**Engineering Exhibit in Support of
Class II Permissive Change Request
FCC Form 731**

DATARADIO HiPR -900

FCC ID: NP4-242-5099-100

Nov 23, 2006

Figure 13 - Setup Wizard - Page One

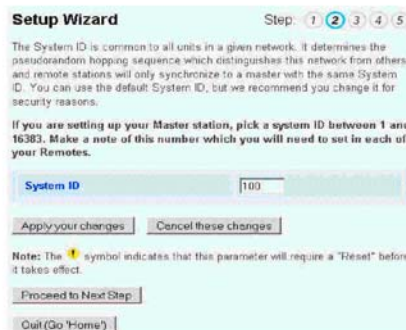
In order to accommodate the Store & Forward Repeater function, the 1st set-up wizard screen (ref. User Manual page 29) is going to have added a “Repeater” option. Since the unit adjustments for “Repeater” function are the same as the ones for “Remote” function, that change is the only one required to user manual. Page 29 will be going to be changed as the below sample page:
